Re: Public Comment Letter for Scott River Valley Draft Groundwater Sustainability Plan

Specific Comments on the Scott River Valley Draft Groundwater Sustainability Plan

Comments on the Scott Groundwater Sustainability Plan

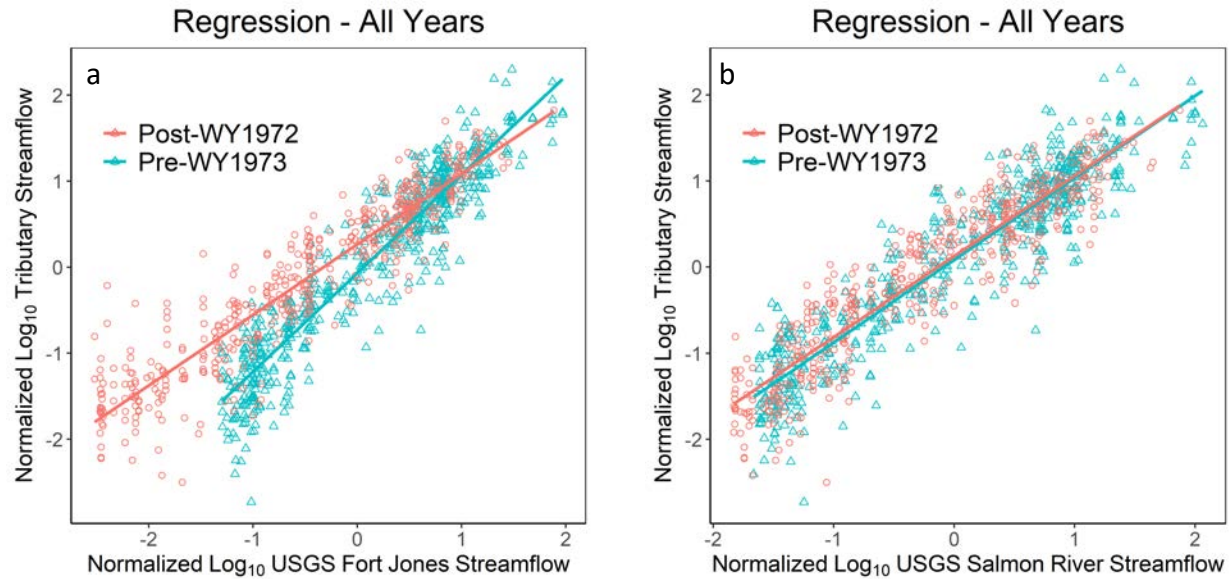
Scott River summer flows appear to have decreased significantly since the 1977 drought, so the data were split and separate regressions were developed for the WY 1957–1972 and WY 1973–2016 study periods (Figure 1a). For those tributaries that do not have any measured data during the WY 1973–2016 period, the WY 1957–1972 regression is used. Given that there is extremely strong evidence that the relationship between tributary flows and Scott River flows changed between the WY 1957–1972 and WY 1973–2016 periods (i.e., Figure 1a), it does not make sense to apply the WY 1957–1972 regressions without adjusting for that difference. Rather than doing two separate regression models (i.e., one for each period), it would make more sense to just have a single regression model covering all years, but include “Period” as a categorical variable (to account for the difference in intercept between the periods), and an interaction of “Period” and Fort Jones (to account for the difference in slope between the periods). In contrast, the current approach does not take maximum use of the available data, ignoring factors that are known to be important (i.e., the difference between the periods).

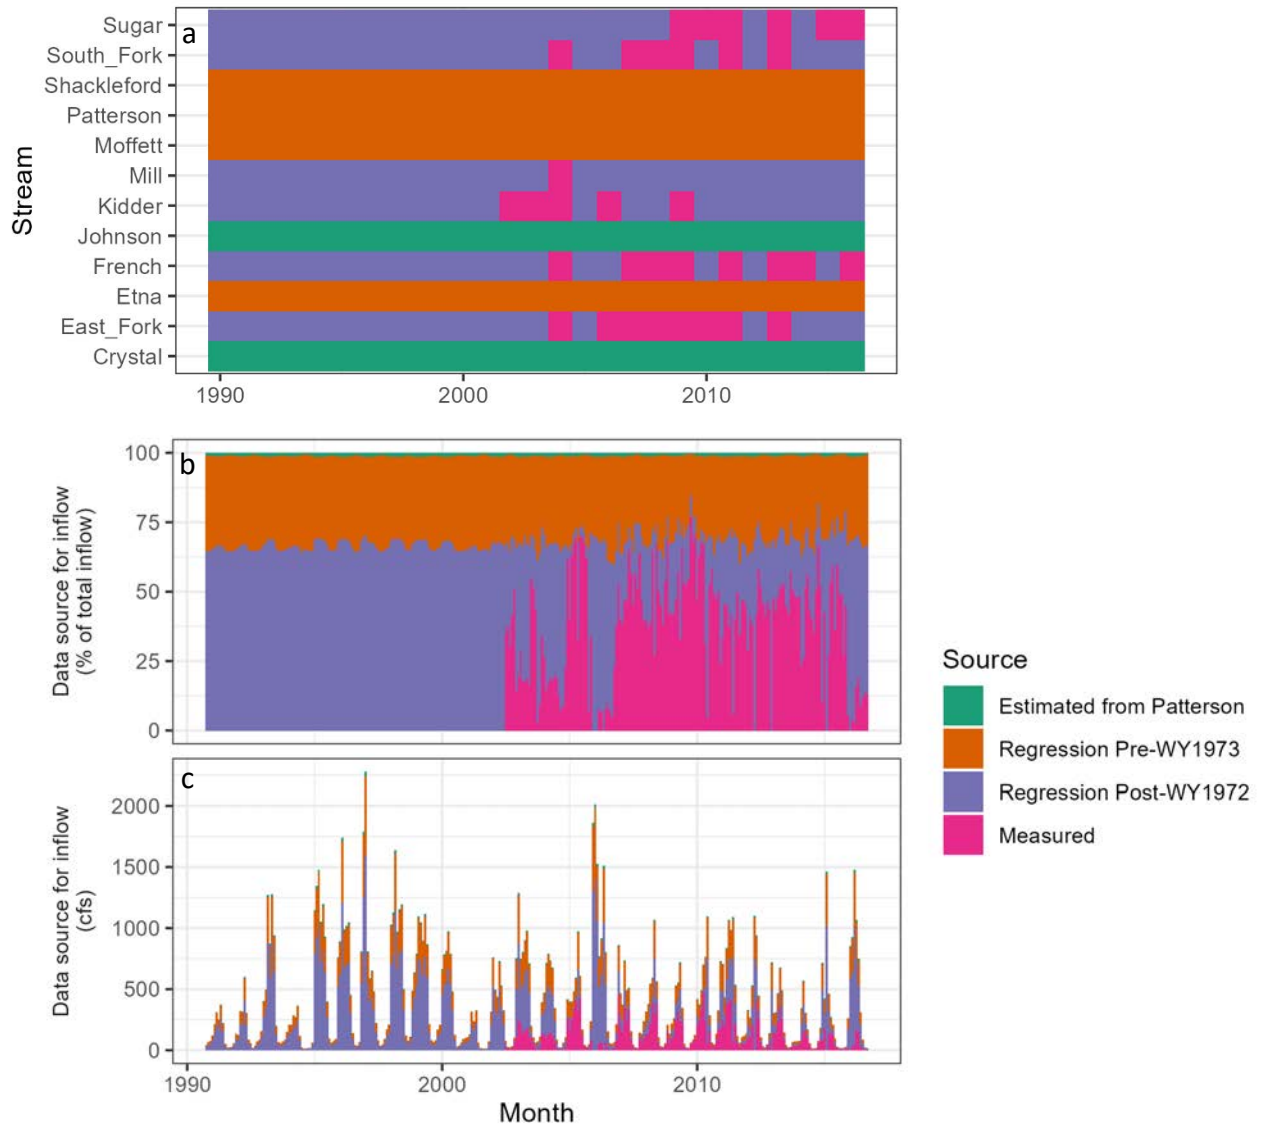
The first thing to recognize about the gap-filling is that gaps are substantial (Figure 2a), so the methods for filling them matters. For the current SGMA GSP, the SVIHM was run for WY1991–2018. Prior to WY 2002, all (100%) of tributaries were estimated using regression against the USGS gage. Since WY 2002, additional gages have been installed but most were operated in only a subset of recent years and now only Sugar Creek and French Creek are still operational (Figure 2). The version of SVIHM used for SGMA did not use any tributary data for 2017-2018. The percent of total estimated inflows in a month that are based on measurements (i.e., gages) only sporadically exceeds 50% (Figure 2b, 2c). The USGS 11519500 gage that is the source for all the regression-based estimates is located at the outlet of Scott Valley. It is problematic to use a gage that is the surface water output of a groundwater basin to estimate the surface water inputs to the same basin, because that groundwater basin exerts profound natural and human influences on hydrology, including water diversions, groundwater pumping, evapotranspiration, groundwater recharge, and leakage of groundwater to streams. In reality, these influences vary not only seasonally (e.g., spring vs. fall) but also inter-annually (i.e., wet years vs. dry years), but using linear regression assumes a constant relationship between the input and output. For example, long-term management changes can affect the relationship between inflows and outflows (i.e., see Figure 1a showing effects of increased groundwater extraction). This gage is also used for calibration and verification of the SVIHM. Given that inflows are an important driver of groundwater dynamics, using the outflow to estimate inflows may artificially inflate the apparent accuracy of the SVIHM (because estimated inflows are automatically scaled based on measured outflows).

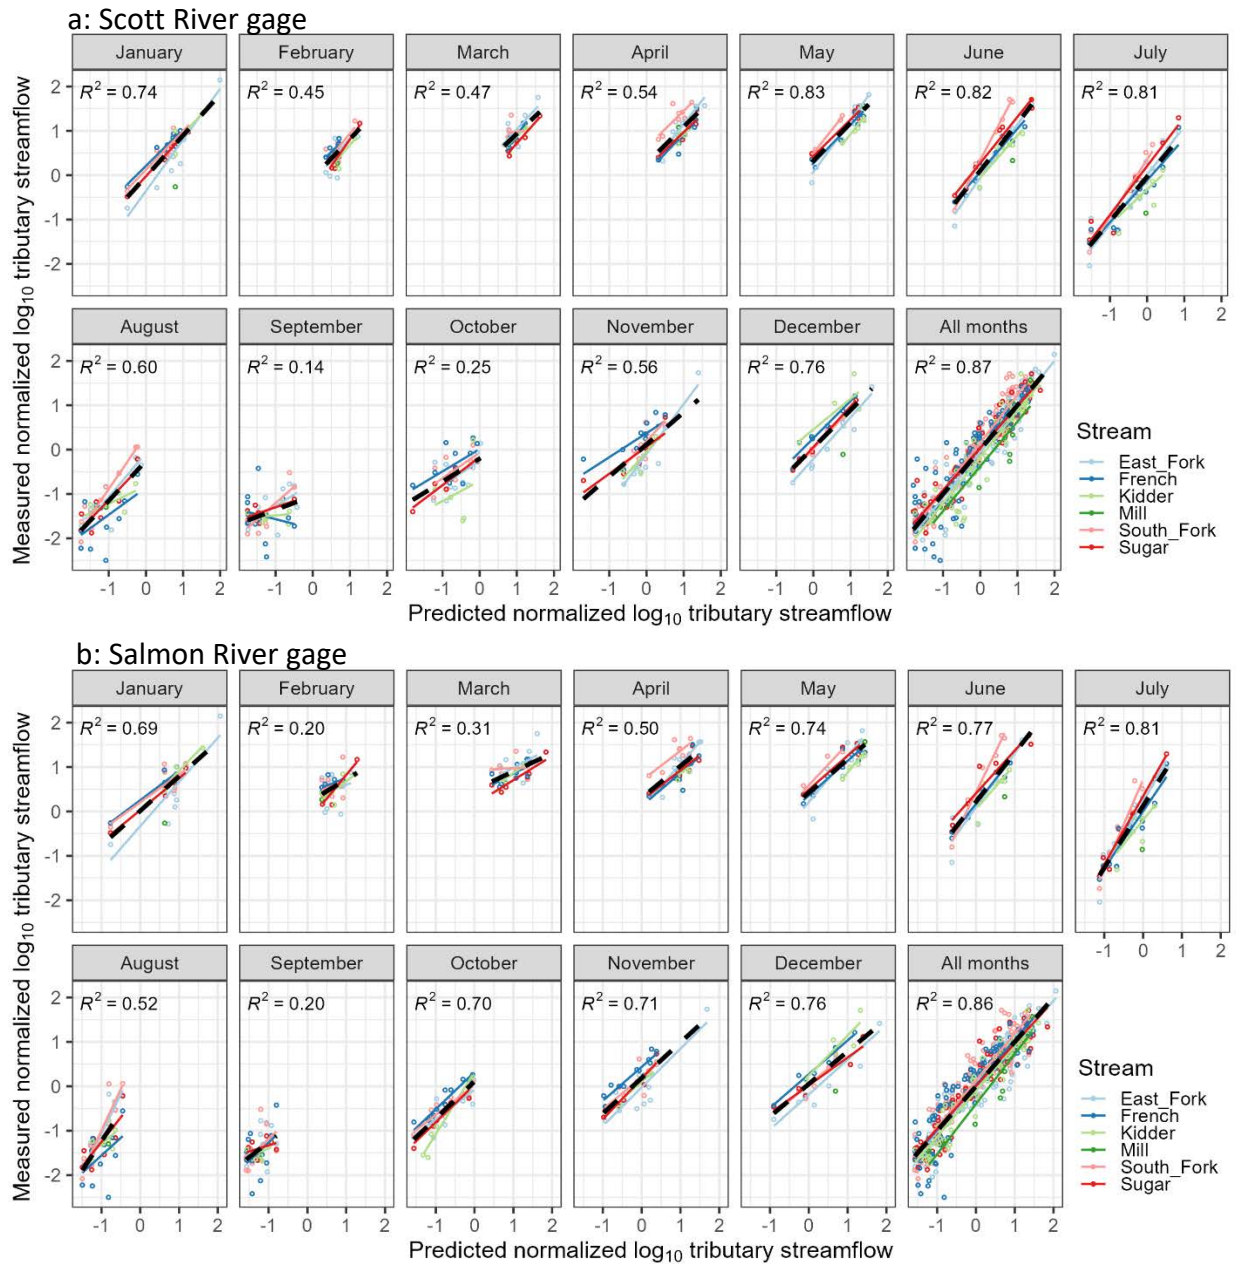
In contrast to the major differences in the relationships between tributaries flows and Scott River flows for the WY 1957–1972 and WY 1973–2016 periods (Figure 1a), there appears to be no difference between the periods when the Salmon River gage is used instead (Figure 1b). The lack of difference between these periods in the Salmon River models suggests that for tributaries that have no post-1972 flow data (i.e., Shackelford, Patterson, and Etna creeks)(Figure 2a), it is likely better to use the Salmon River model for gap-filling additional months (i.e., maybe June–December for these tributaries, instead of the September–November we are recommending for the other tributaries?). The recommendation for June–December is based on the observation that the between-period divergence occurs at normalized \log_{10} Scott River flows less than zero (Figure 1a) and in the WY 1973–2016 period such flows tend to occur more frequently in June–December than other months (Figure 4a).

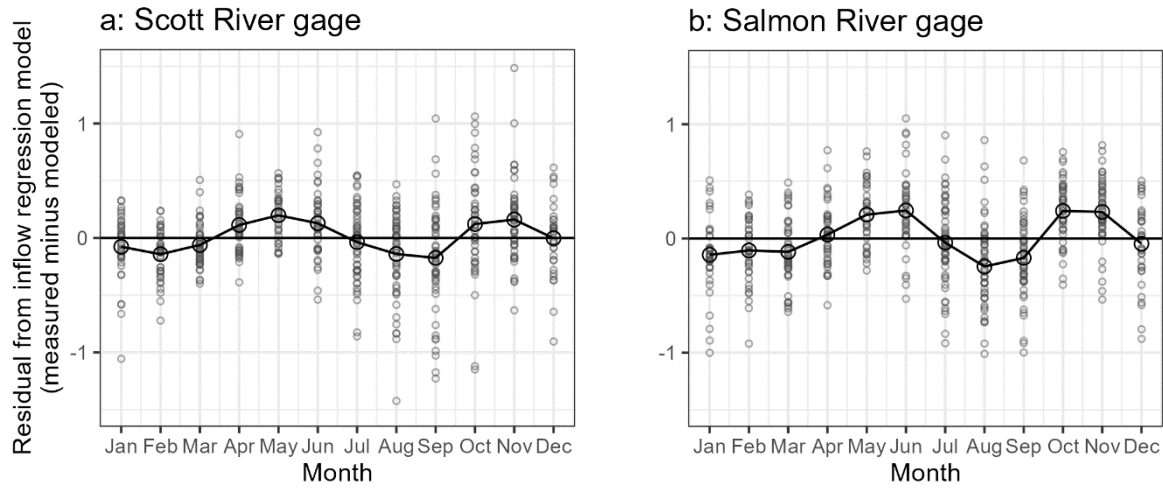
One additional suggestion for potential additional refinements to the methods for filling data gaps that we do not currently have time to test, but want to mention here so it could potentially be followed up on later, is to use hierarchical models and account for watershed area. The SVIHM's normalization (a.k.a. "standardizing", our preferred term) of the flow data (subtracting the mean and dividing by standard deviation, with the mean and standard deviation calculated individually for each site based on that site's period of record) is intended to allow all tributaries to be included together in the same regression model. However, we have some concerns that for sites with short records (e.g., 11 months at Mill Creek, 6 months at Etna and Patterson creeks), there are far too few data points for the mean and standard deviation to be representative of long-term patterns, which could lead to artifacts in the regression outputs. A possibly more robust alternative would be to instead convert the flow data to specific discharge (i.e., flow per watershed area in units of cfs/mi² or its metric areal equivalent mm/d), then standardizing by subtracting the mean and dividing by standard deviation (with the mean and standard deviation calculated from the entire pool of specific discharges from all sites, rather than calculating the mean and standard deviation only from each site's period of record). From these standardized specific discharges, a single hierarchical model (a.k.a. mixed effects model) could be constructed with appropriate random effects to explicitly account for inter-site differences. R packages available for implementing such models include 'mgcv', 'lme4', and 'nlme'. A hierarchical model could help account for inter-site differences. For example, not surprisingly given its the relatively low elevation watershed, Moffett Creek appears to have a greater percent of its annual flow occur during January–March than other tributaries and then a lesser percent of its annual flow occurs during May–June snowmelt runoff (not shown here). There are clear, albeit relatively small, seasonal patterns in the residuals (calculated as measured minus modeled) in both the Scott River and Salmon River regression models, with both models under-predicting tributary flows in May–June and October–November underpredicting tributary flows in January–March and August–September (Figure 5). A hierarchical model would likely help remove the seasonal patterns in model residuals.

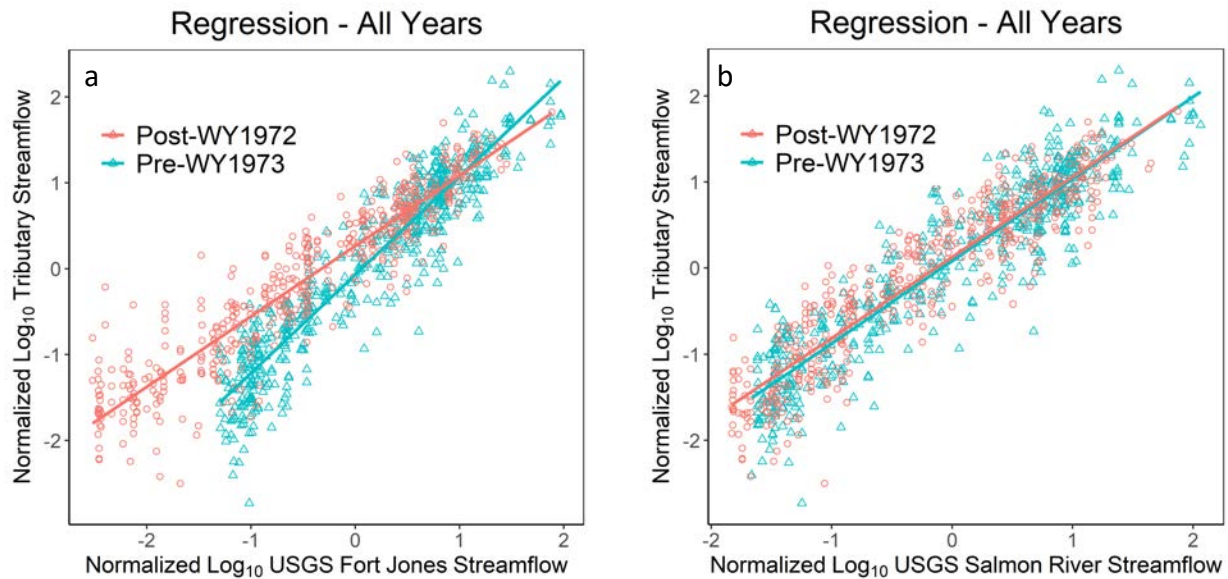
Scott River summer flows appear to have decreased significantly since the 1977 drought, so the data were split and separate regressions were developed for the WY 1957–1972 and WY 1973–2016 study periods (Figure 1a). For those tributaries that do not have any measured data during the WY 1973–2016 period, the WY 1957–1972 regression is used. Given that there is extremely strong evidence that the relationship between tributary flows and Scott River flows changed between the WY 1957–1972 and WY 1973–2016 periods (i.e., Figure 1a), it does not make sense to apply the WY 1957–1972 regressions without adjusting for that difference. Rather than doing two separate regression models (i.e., one for each period), it would make more sense to just have a single regression model covering all years, but include “Period” as a categorical variable (to account for the difference in intercept between the periods), and an interaction of

“Period” and Fort Jones (to account for the difference in slope between the periods). In contrast, the current approach does not take maximum use of the available data, ignoring factors that are known to be important (i.e., the difference between the periods).

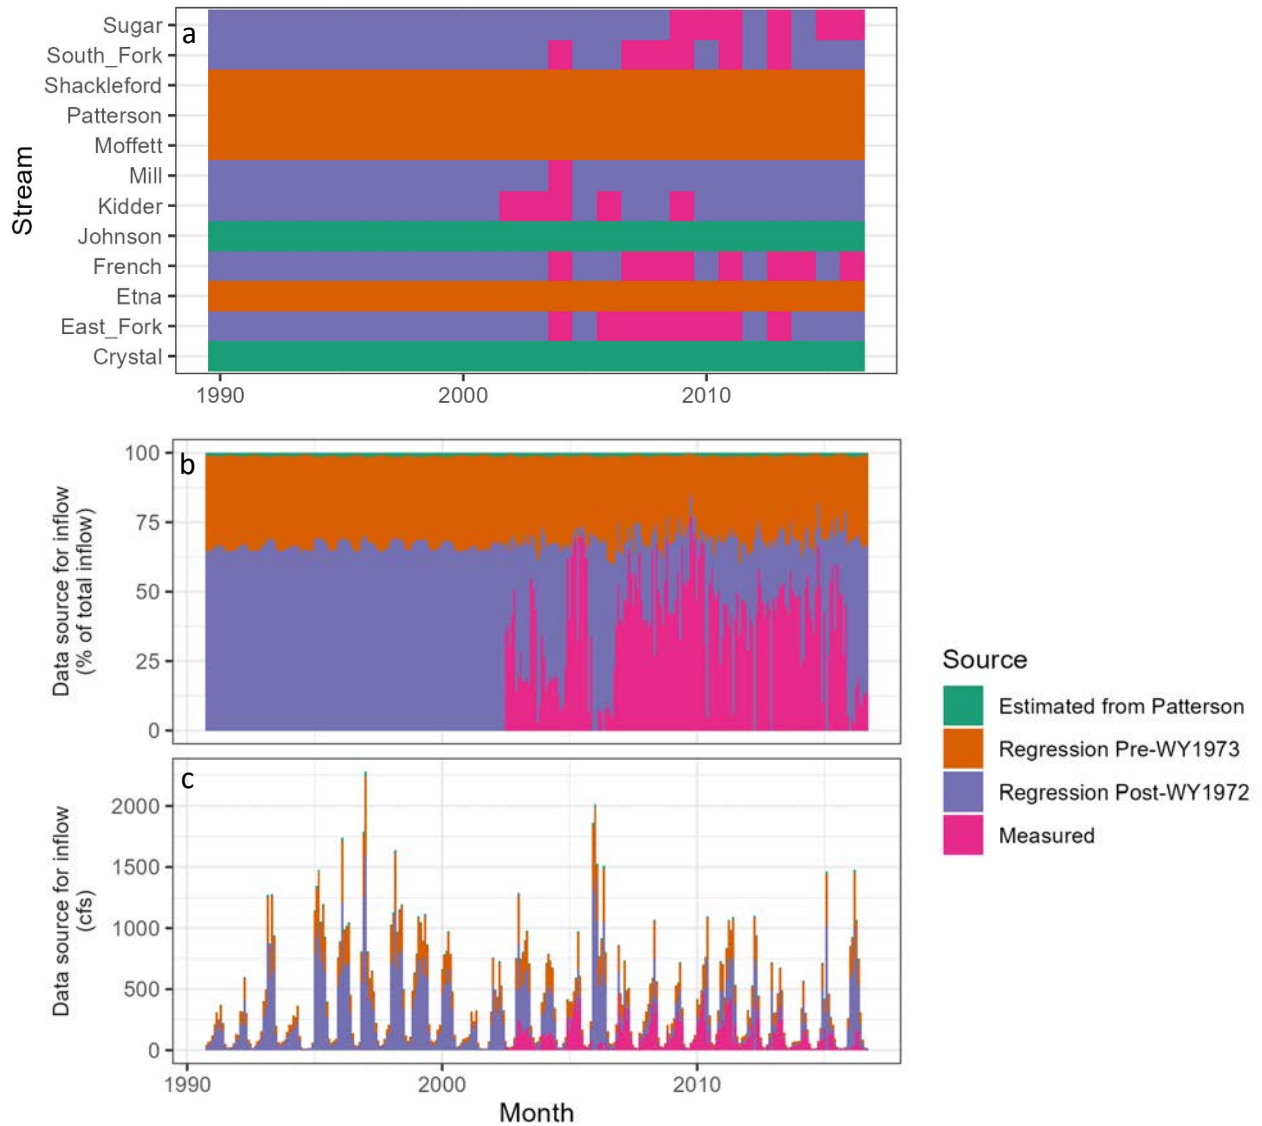
The first thing to recognize about the gap-filling is that gaps are substantial (Figure 2a), so the methods for filling them matters. For the current SGMA GSP, the SVIHM was run for WY1991–2018. Prior to WY 2002, all (100%) of tributaries were estimated using regression against the USGS gage. Since WY 2002, additional gages have been installed but most were operated in only a subset of recent years and now only Sugar Creek and French Creek are still operational (Figure 2). The version of SVIHM used for SGAM did not use any tributary data for 2017-2018. The percent of total estimated inflows in a month that are based on measurements (i.e., gages) only sporadically exceeds 50% (Figure 2b, 2c). The USGS 11519500 gage that is the source for all the regression-based estimates is located at the outlet of Scott Valley. It is problematic to use a gage that is the surface water output of a groundwater basin to estimate the surface water inputs to the same basin, because that groundwater basin exerts profound natural and human influences on hydrology, including water diversions, groundwater pumping, evapotranspiration, groundwater recharge, and leakage of groundwater to streams. In reality, these influences vary not only seasonally (e.g., spring vs. fall) but also inter-annually (i.e., wet years vs. dry years), but using linear regression assumes a constant relationship between the input and output. For example, long-term management changes can affect the relationship between inflows and outflows (i.e., see Figure 1a showing effects of increased groundwater extraction). This gage is also used for calibration and verification of the SVIHM. Given that inflows are an important driver of groundwater dynamics, using the outflow to estimate inflows may artificially inflate the apparent accuracy of the SVIHM (because estimated inflows are automatically scaled based on measured outflows).

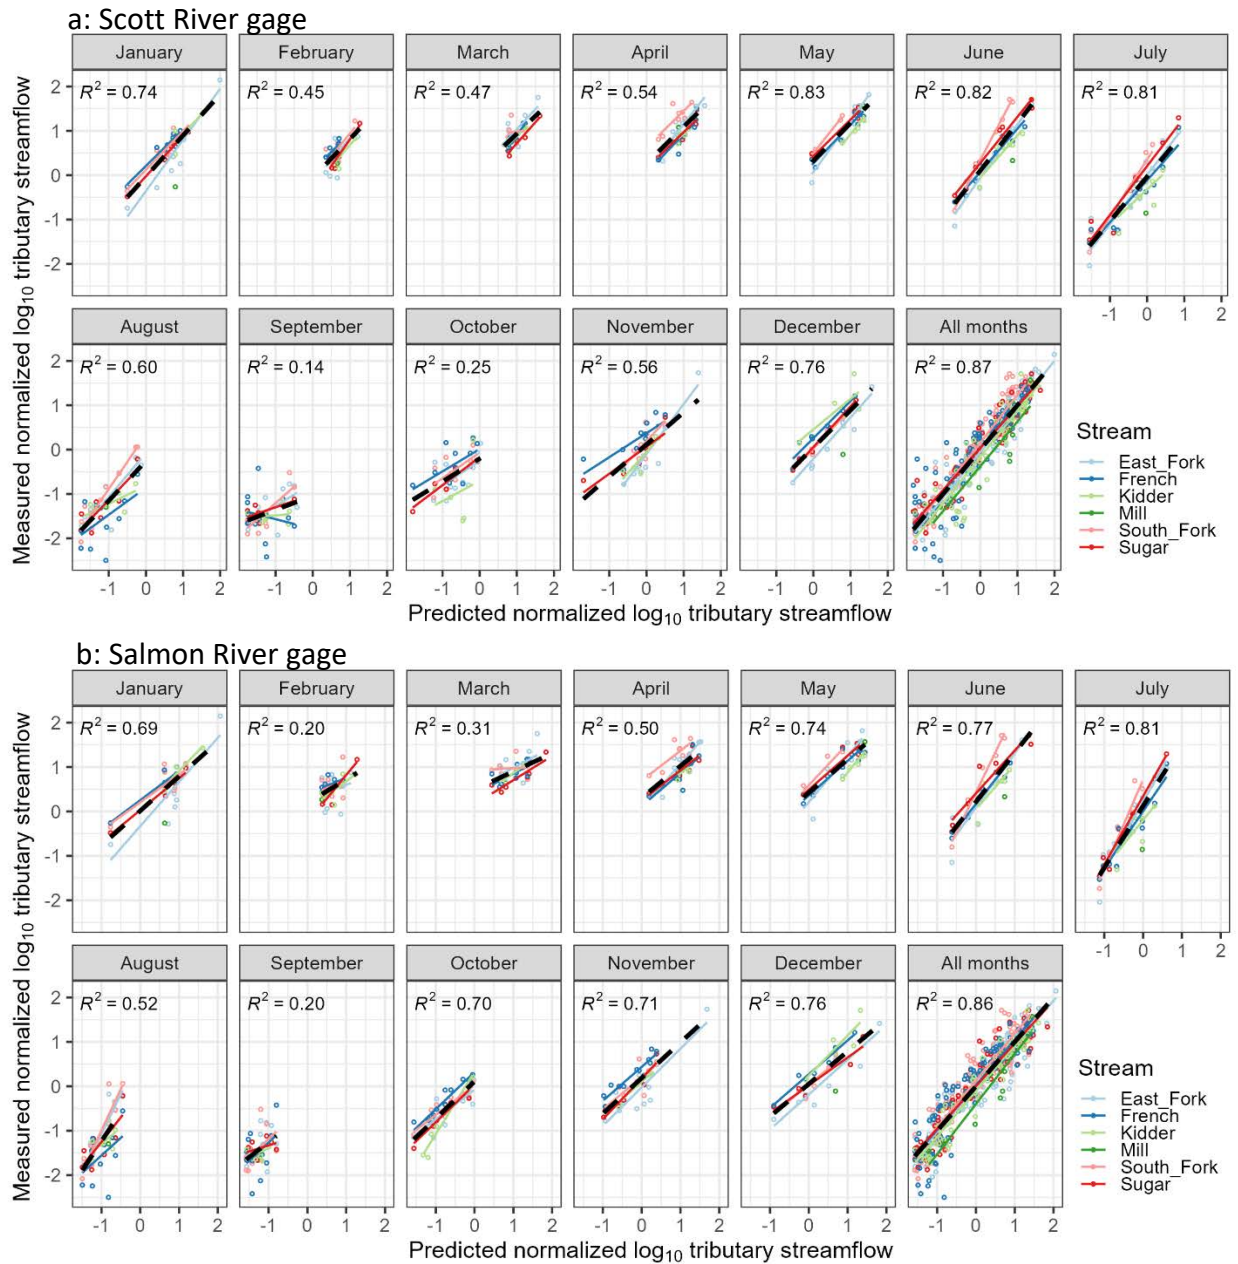
In contrast to the major differences in the relationships between tributaries flows and Scott River flows for the WY 1957–1972 and WY 1973–2016 periods (Figure 1a), there appears to be no difference between the periods when the Salmon River gage is used instead (Figure 1b). The lack of difference between these periods in the Salmon River models suggests that for tributaries that have no post-1972 flow data (i.e., Shackelford, Patterson, Moffett, and Etna creeks)(Figure 2a), it is likely better to use of Salmon River models for gap-filling additional months (i.e., maybe June–December for these tributaries, instead of the September–November we are recommending for the other tributaries?). The recommendation for June–December is based on the observation that the between-period divergence occurs at normalized \log_{10} Scott River flows less than zero (Figure 1a) and in the WY 1973–2016 period such flows tend to occur more frequently in June–December than other months (Figure 4a).
